**PCN# : P698AAB**  
**Issue Date : Sep. 19, 2016**

**Information Only Notification**

Figure 3. Typical Forward Voltage Drop vs. Forward Current

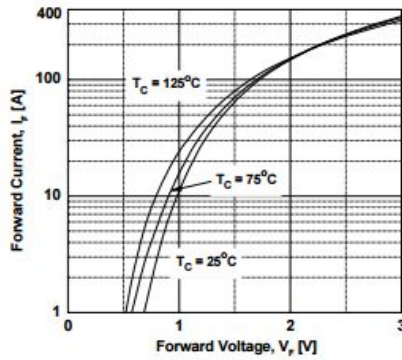
2. Updated figure 3,4, 6,7 and 8 (page 3)

2. Updated figure 3,4, 6,7 and 8 - to add +175C data points
